<b>Specification</b>	<b>Document</b> E94738
	AUDICOR® AM Product Labeling	<b>Revision</b>
		<b>Page</b> 1 of 8

Enclosure Back (40215)

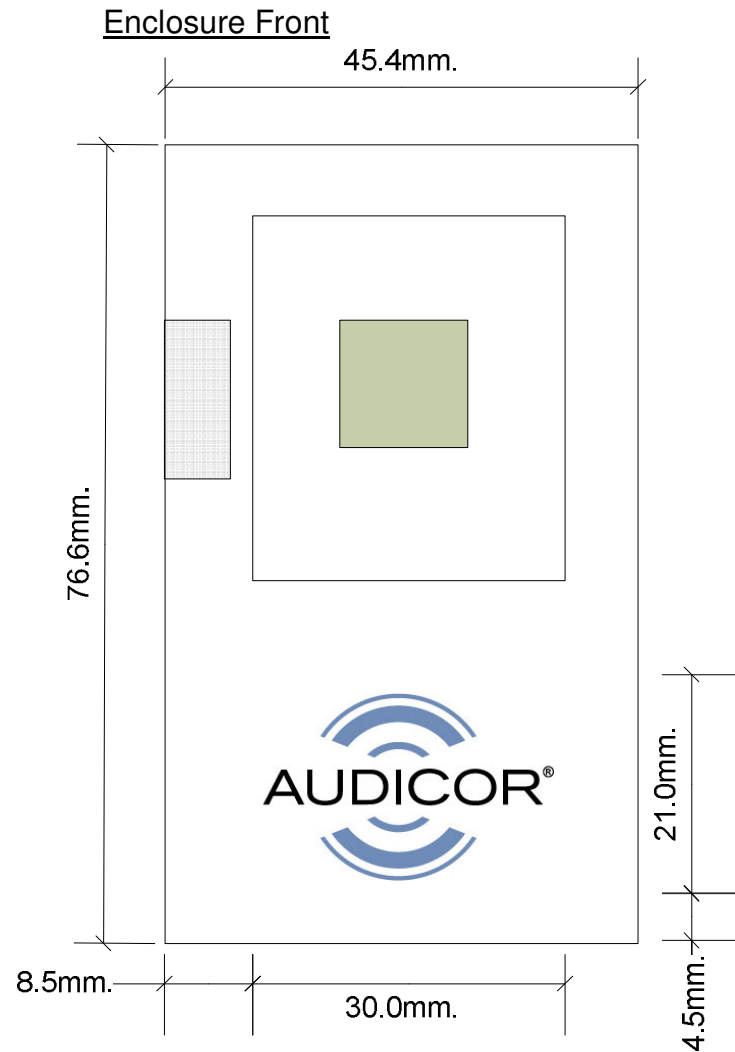
Revision	ECO #	Effective Date	Description of Change	Originator
x.1		9/16/09	Initial engineering revision	Alan A.
x.2		9/18/09	Changed Model # from 300J to PC1C on label 40214 per YIP request	Alan A.
x.3		10/2/09	Changed FCC ID from V2L-TD1A to V2L-PC1C on label 40214	Alan A.
x.4		10/2/09	Fixed error in battery capacity and added symbol for "see accompanying documents" to battery label 40216	Alan A.
x.5		10/7/09	Removed FCC logo from enclosure label 40214 per FCC instructions	Alan A.
